Landscape Design Review

Hinckley National Rail Freight Interchange (HNRFI)

Version 2.0
August 2023
Prepared by LUC

Blaby District Council (BDC) and Hinckley and Bosworth
Borough Council (HBBC)

Overlay of proposed development and existing green infrastructure (red). Illustrating the applicant's approach to removal of the existing green assets in relation to the parameter plan.

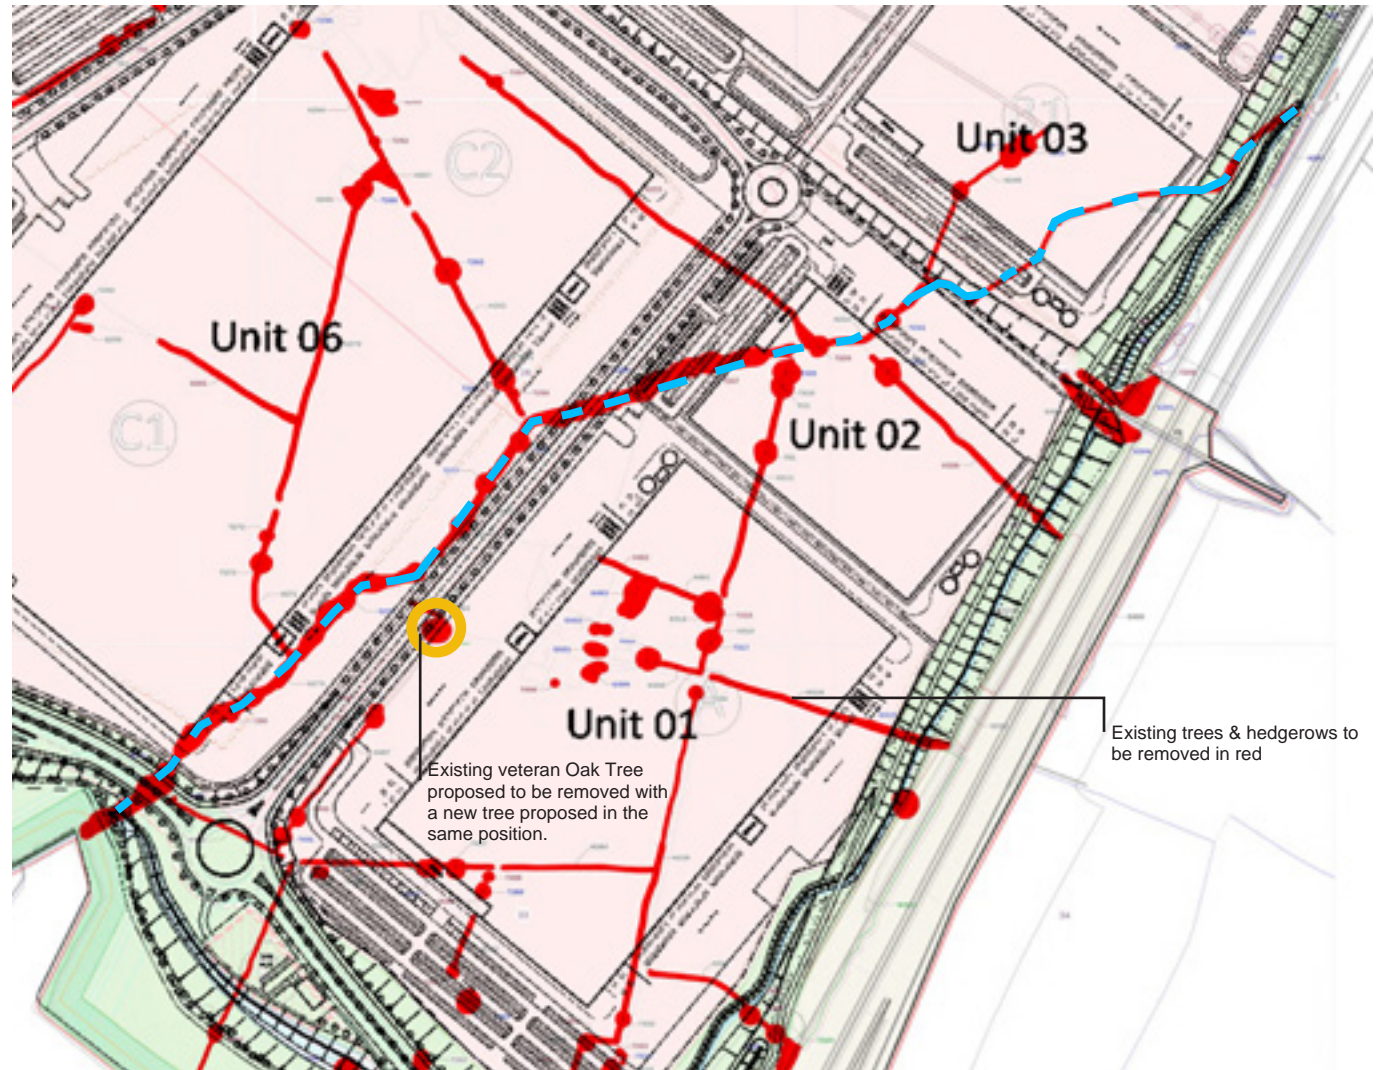
The site and adjacent area contains existing irreplaceable habitat including T486 Veteran English Oak which is set to be removed. The applicant has not provided sufficient information on mitigation measures for protecting adjacent Ancient Woodland. The proposed 50m buffer is unlikely to form sufficient protection with the proposals having a direct negative impact on these receptors.

The majority of the open space within the design (annex 2) is hard landscaped, which will cause a significant effect to the ecosystems and loss in biodiversity on site not aligning with prioritising nature. The inclusion of SuDS is welcomed but this opportunity could have been taken further in integrating into existing networks.

Extract of the applicant's illustrative masterplan illustrating the heavily programmed site layout offering little opportunity for rest or amenity.

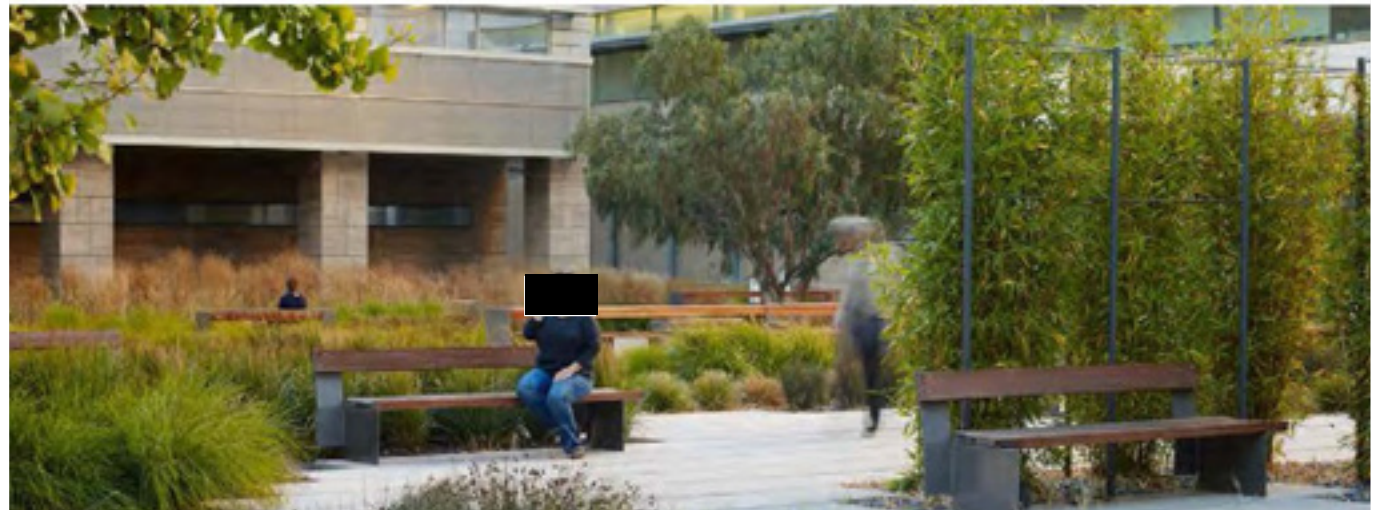
The majority of the external space has been designed solely for operational benefit, with little regard to the design of communal public spaces for amenity. The masterplan is led by the infrastructure and offers little in regard to the experience of everyday users and pedestrians passing through the site.

There is minimal provision for activities or gathering opportunities within external spaces. A few features are placed to the edge of the site such as outdoor exercise equipment and seating but these do not feel integrated into the design and appear isolated. The masterplan (annex 2) currently offers limited opportunities for social interaction.

Scheme Parameter Plan

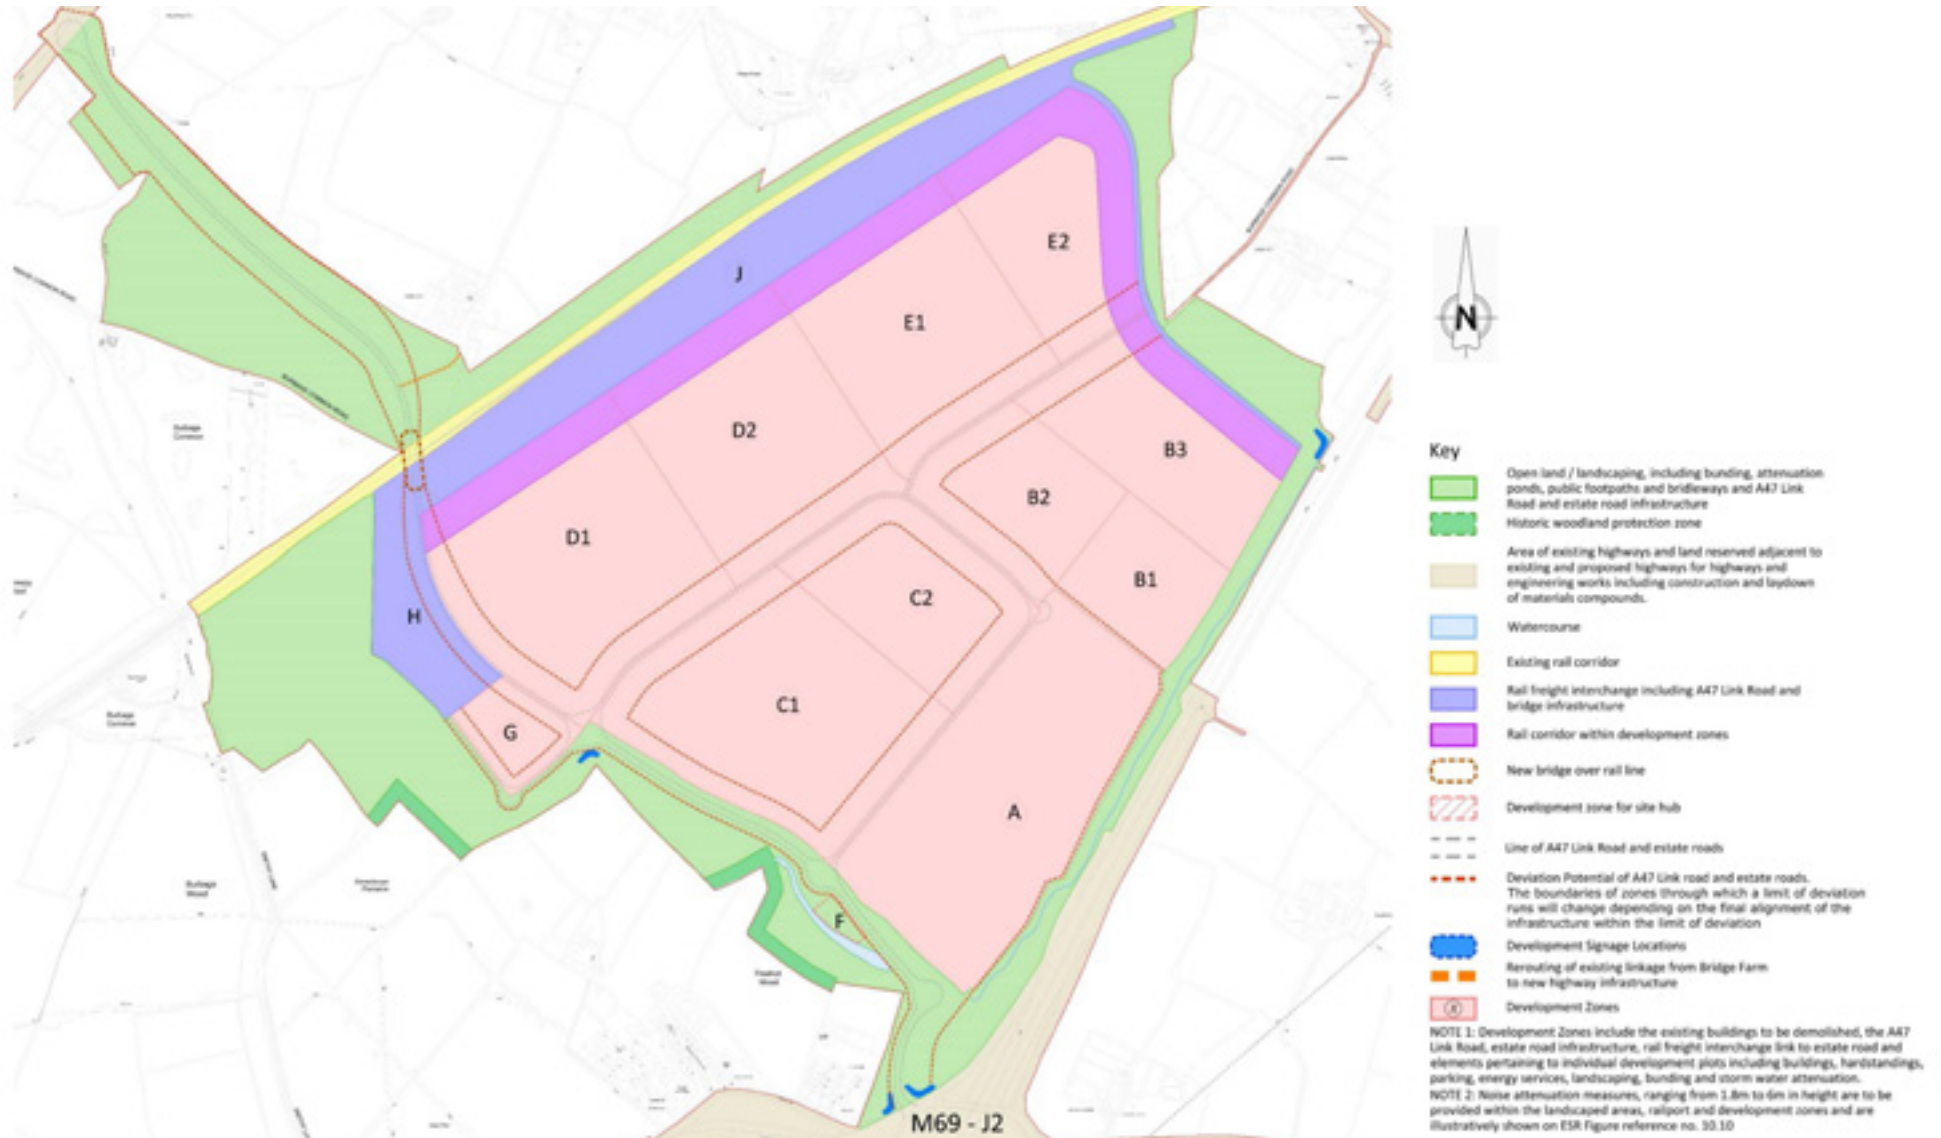
Although there has been an optioneering process to arrive at the current scheme which is welcomed, the process does not appear to have challenged the parameter plan (annex 1) which is fundamental in setting the development down it's current trajectory.

The parameter plan (Annex 1) dictates site clearance within its primary development zone and creates one large development plateau. This forms the majority of the site and removes the current grain of the landscape which integrates it into its context. Without this common grain the development is rather inward looking proposing a new layout that is more uniform lacking cohesion with its surroundings. The creation of a series of development plots responding to the existing levels of the site rather than to the rail levels appears not to have been considered.

3.6 The scale of the development is set by the parameter plan (Annex 1). This designates the primary development zone as well as areas forming a landscape buffer. The latter are in reality fringe pieces of land that due to lack of space fail to accommodate the necessary mitigation on site to appropriately screen the development. The NPS states '*the Secretary of State may decide that the benefits of the mitigation to reduce the landscape effects outweigh the marginal loss of scale or function.*' (5.159 NPS National Networks). The found significant visual effects are certainly cause to review the scale and overall density of the development that currently cannot adequately be mitigated by the landscape proposals.

3.7 The proposal could be improved by reviewing the parameter plan (Annex 1) to ensure that proper allowances are made for green space both to buffer the development and accommodate replaced green infrastructure (if removal of the exiting is unavoidable). Currently the scale of green space provided is not commensurate with the scale of the surrounding built environment. The masterplan (Annex 2) should provide meaningful green space that is integrated throughout helping to lessen the scale of proposals and soften the scheme from within as well as when viewed from the outside.

Illustrative phasing and works plan

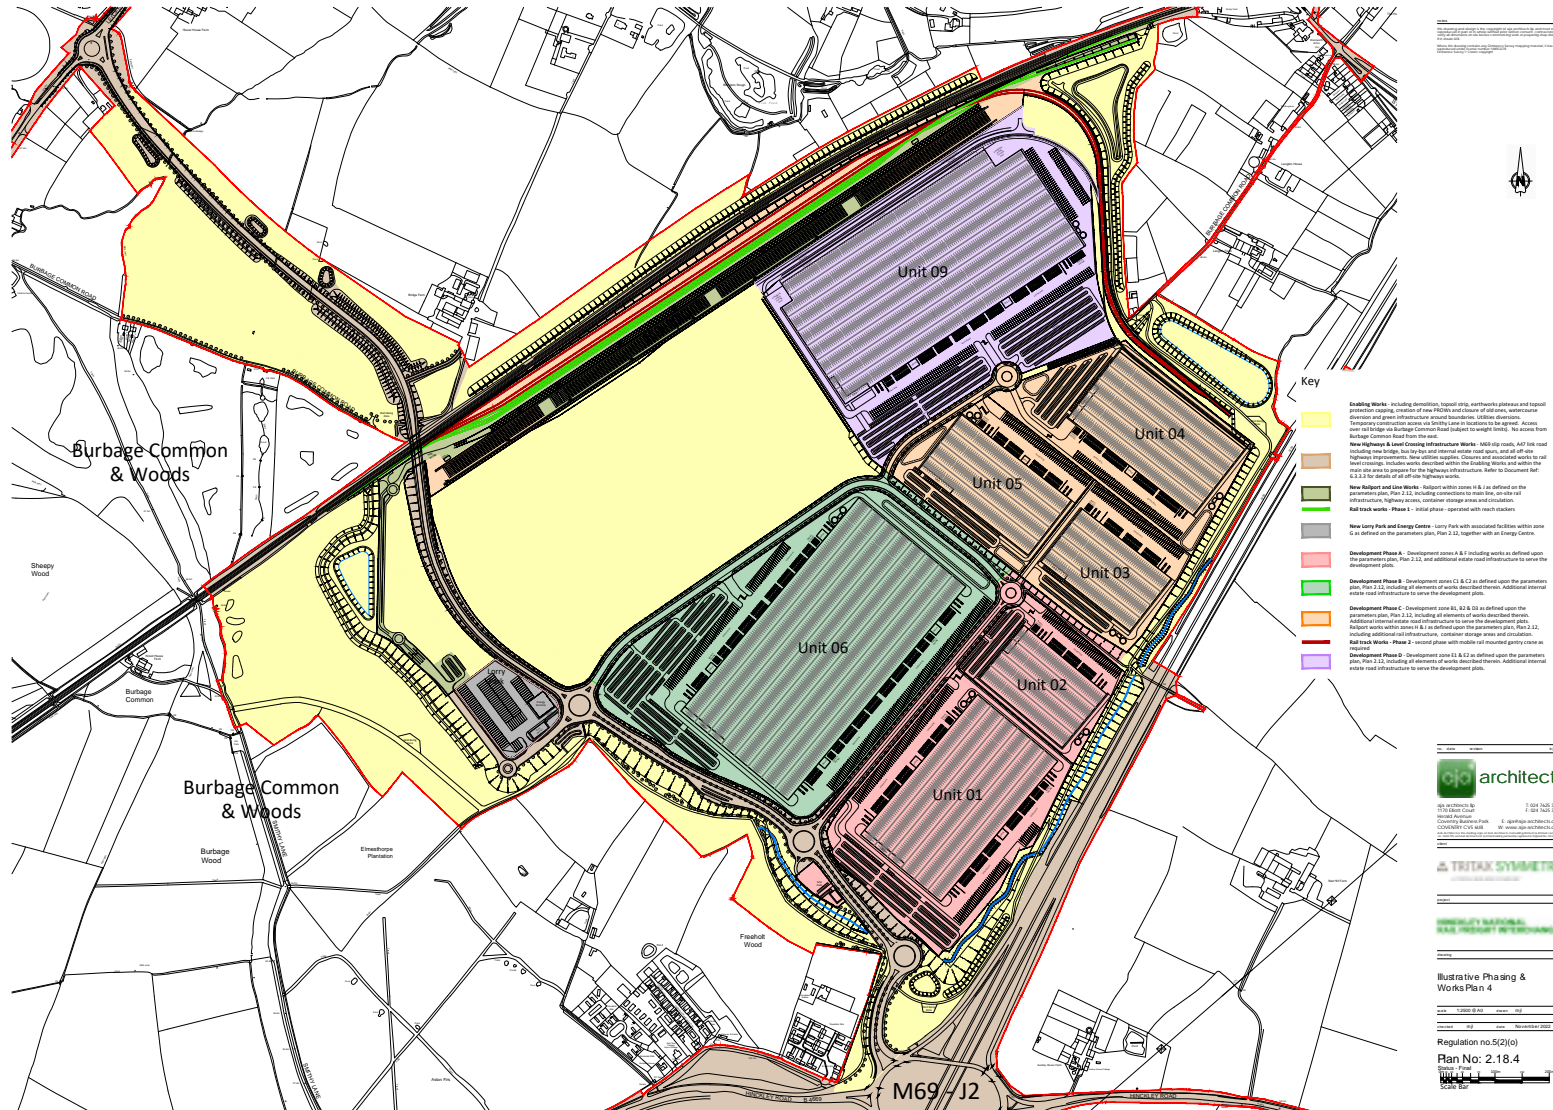
The development proposes to remove all green infrastructure from the primary development zone (annex 1 & 3) of the site and proposes a new layout for this in line with the site infrastructure.

3.10 The proposals are largely formed by the parameter plan (Annex 1). All of the existing landscape features within the primary development zone are proposed to be cleared (Annex 3 Illustrative phasing and works plan). This includes a number of high value trees including a veteran Oak, a watercourse and an extensive hedgerow network. The draft NPS states *'The Secretary of State should not grant development consent for any development that would result in the loss or deterioration of irreplaceable habitats including ancient woodland and ancient or veteran trees unless there are wholly exceptional reasons...'* (5.58 Draft NPS National Networks). This is reflected in the current NPS which makes clear that the removal of veteran trees are only acceptable where loss is proven to be unavoidable. The approach to the existing green infrastructure appears dismissive of the existing and the proposed new landscape framework is inadequate in
